**Re: City of Albemarle Landfill
Leachate System Improvements
HHNT Project No. 1011-010-01**

LEACHATE COLLECTION IMPROVEMENT PLAN
CITY OF ALBEMARLE MSW LANDFILL

PROPOSED LEACHATE COLLECTION SYSTEM MUNICIPAL SOLID WASTE LANDFILL FACILITY PLAN FOR CITY OF ALBEMARLE STANLY COUNTY, NORTH CAROLINA			
HODGES, HARBIN, NEWBERRY & TRIBBLE, INC.		3920 ARKWRIGHT RD. SUITE 101 MACON, GEORGIA 31210	
Consulting Engineers NC-Corp. License No. C-0813			
PROJ. NO.	1011-011-01	DWG. ALB-FP UPDATE-L-R	EDIT 04-20-12
SCALE	1" = 200'		
DATE	APRIL 2012		
			SHEET 5 OF 10

LEACHATE MANHOLE DETAILS

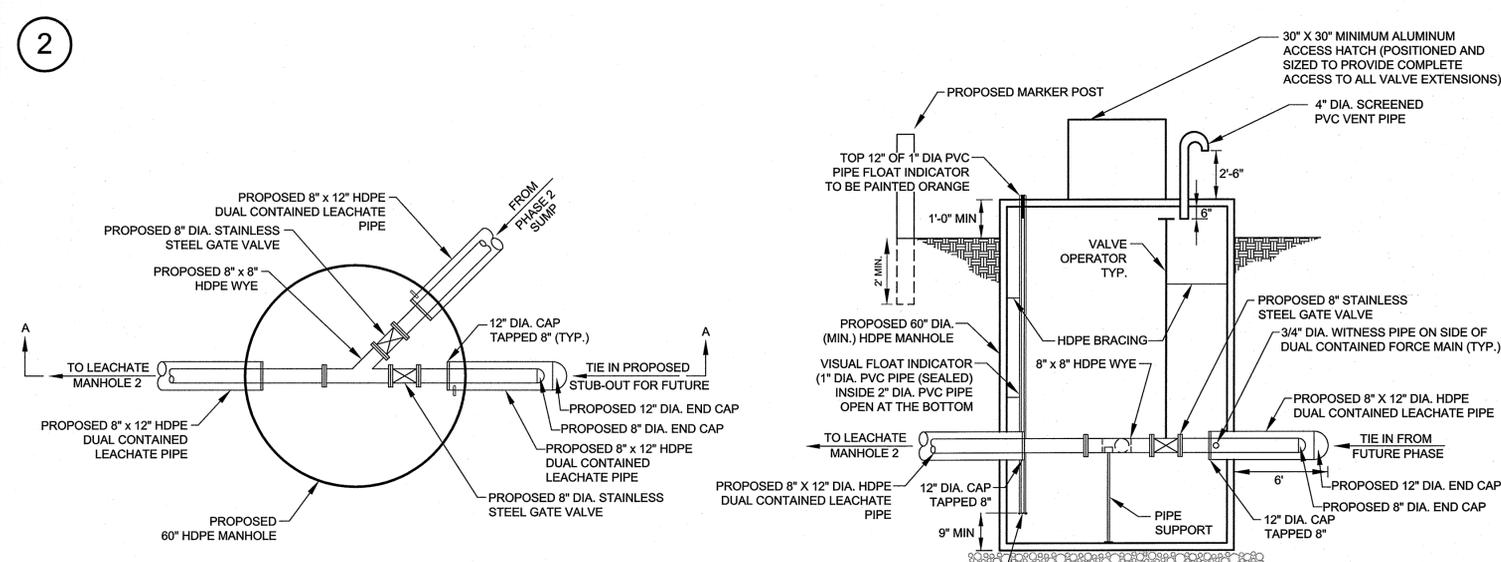
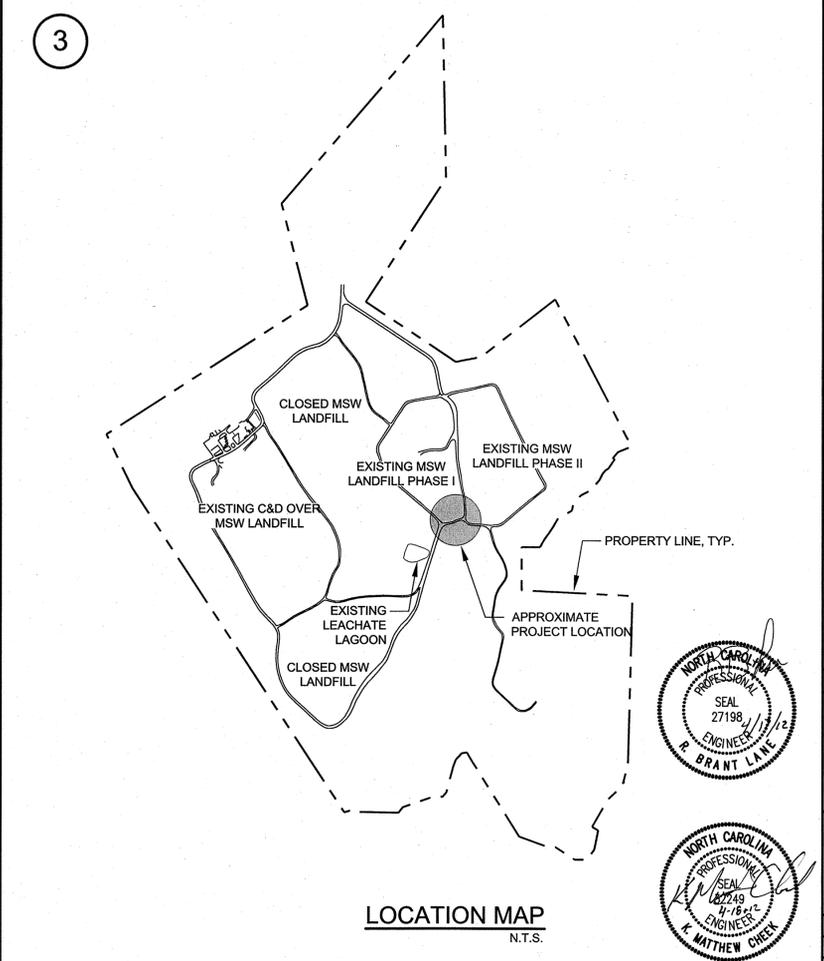
We have enclosed the plan sheet showing proposed leachate system improvements for the Phase 1 and Phase 2 areas of the lined MSW landfill area. The proposed improvements will eliminate any leachate flow on the portion of the Phase 2 leachate collection line thought to have a leak in the primary containment pipe or valves leaving Phase 2. Upon your approval of the attached plan, the City of Albemarle will proceed with construction of the improvements.

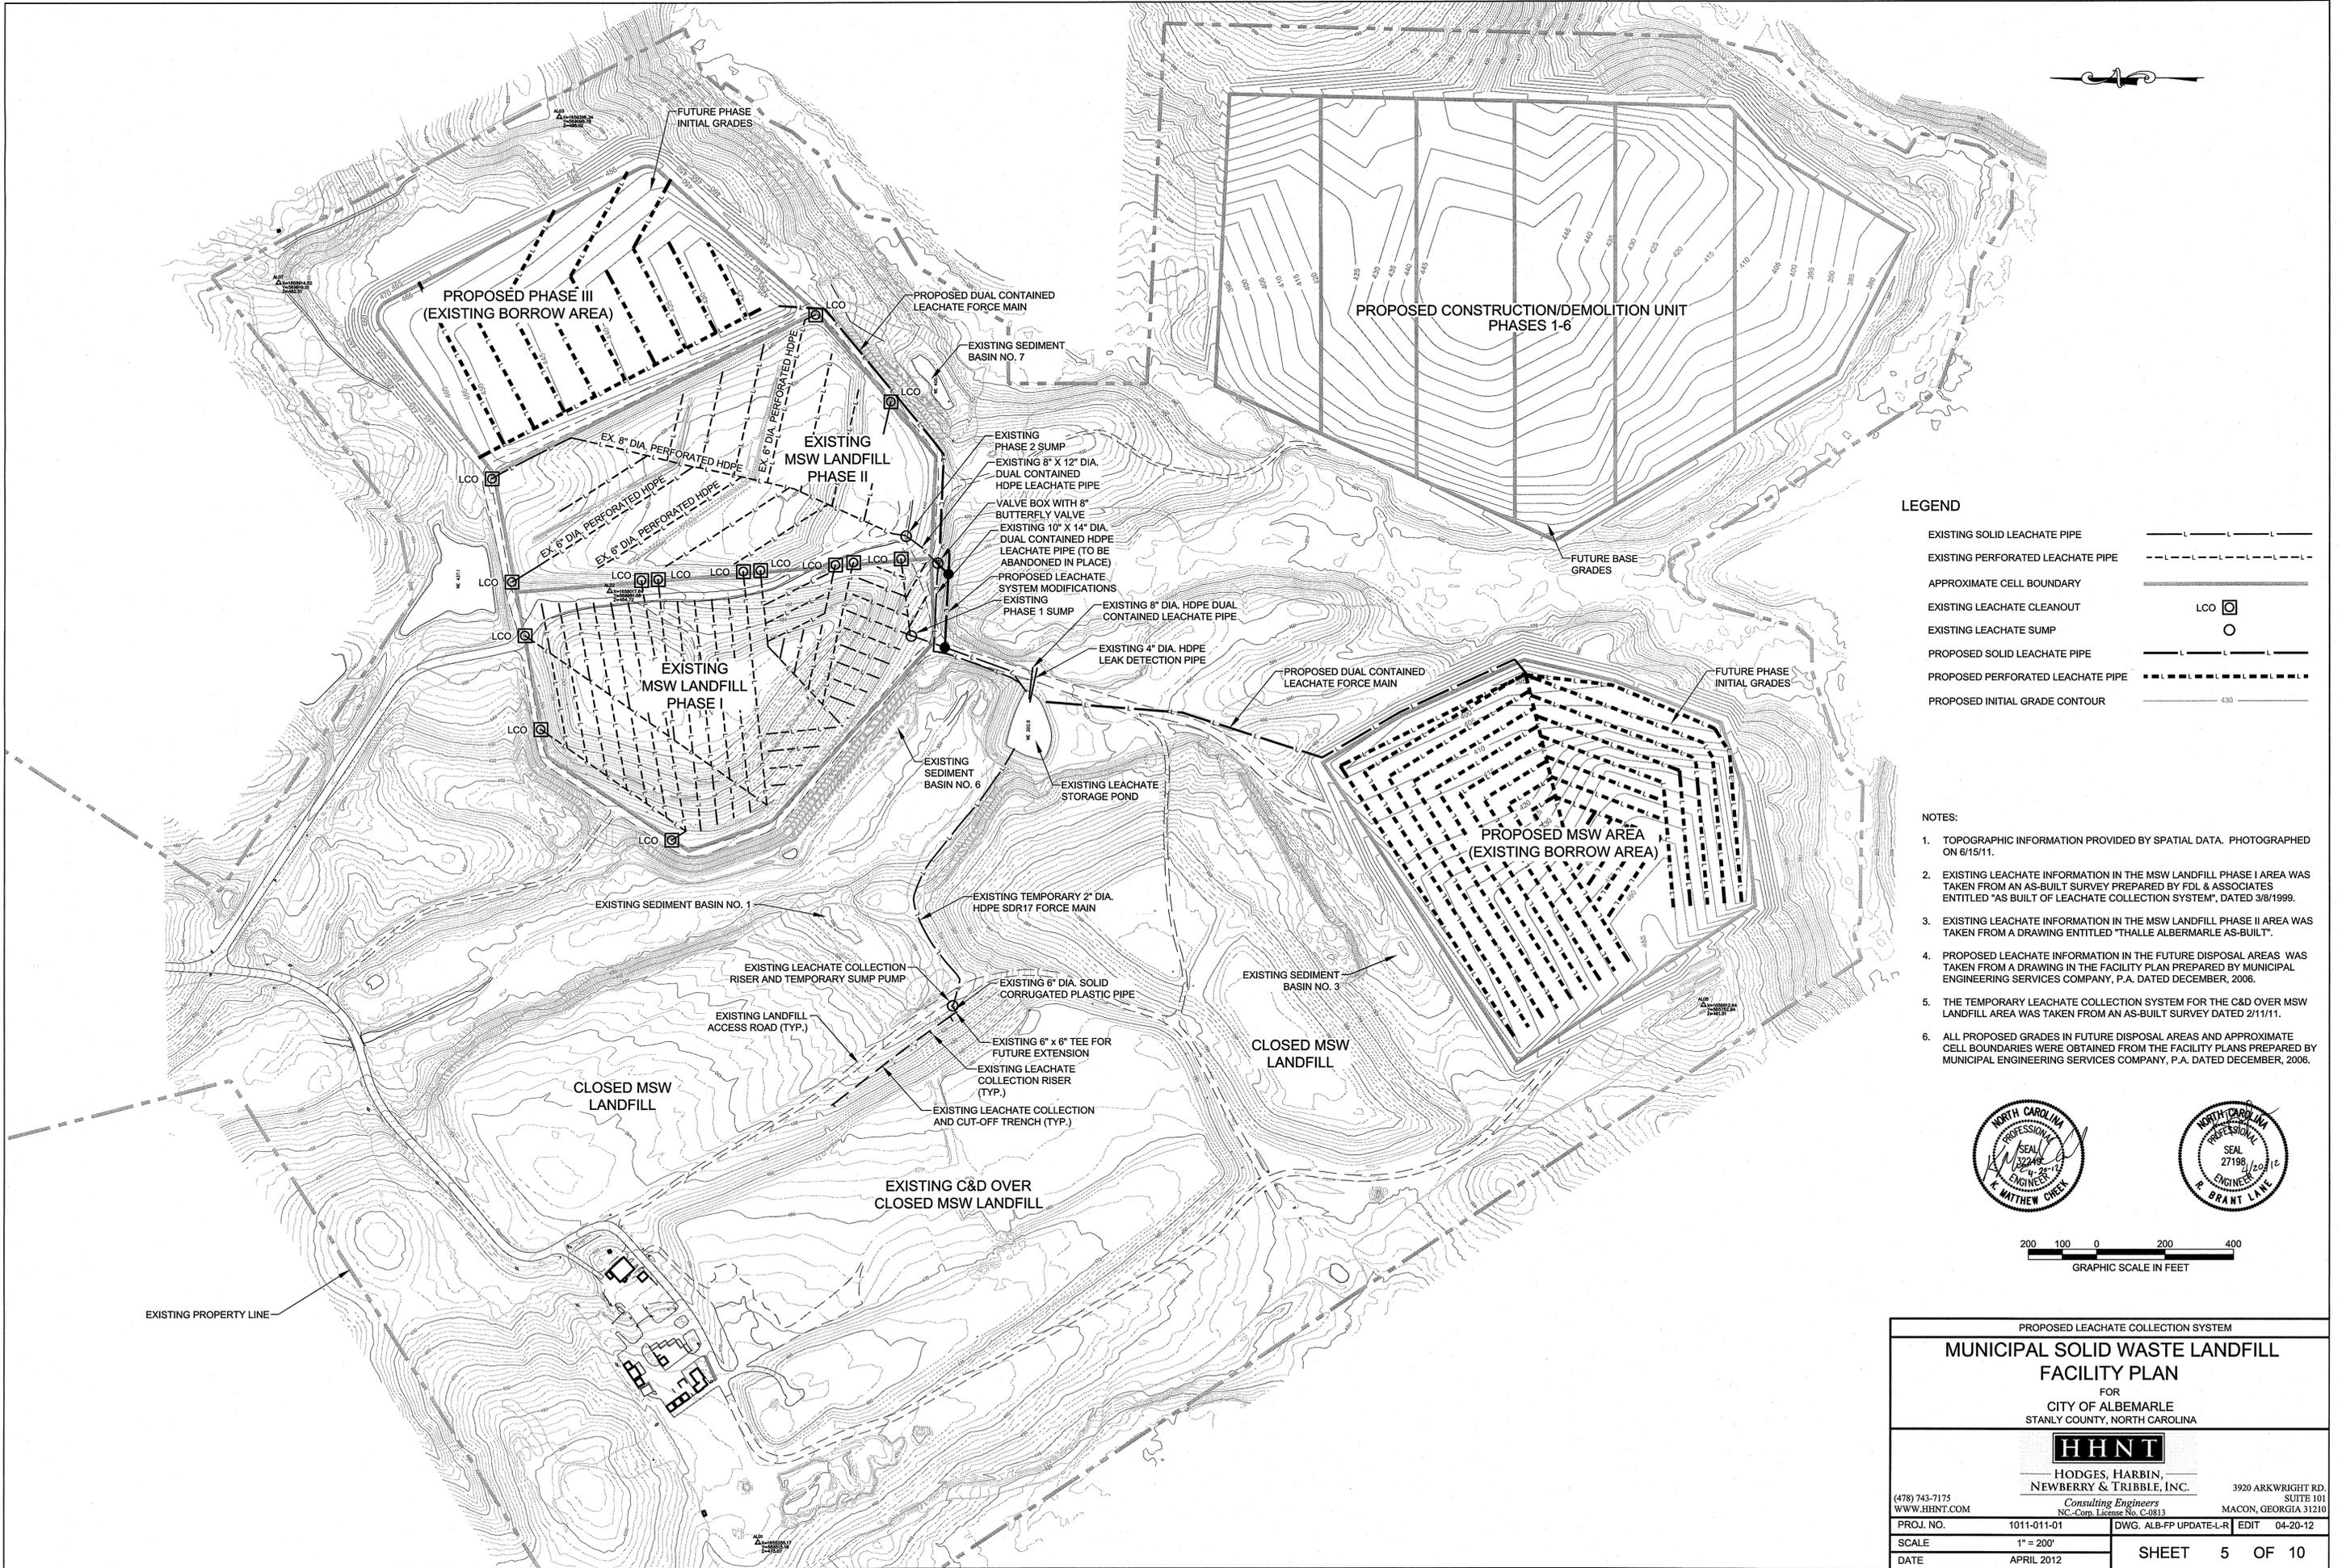
During your latest site visit, you requested an updated leachate plan for the facility to show the leachate lines installed in the C&D area and the proposed Phase 2 leachate improvements. To honor this request, we have also included a revised sheet 5 of 10 from the Facility Plans for your review.
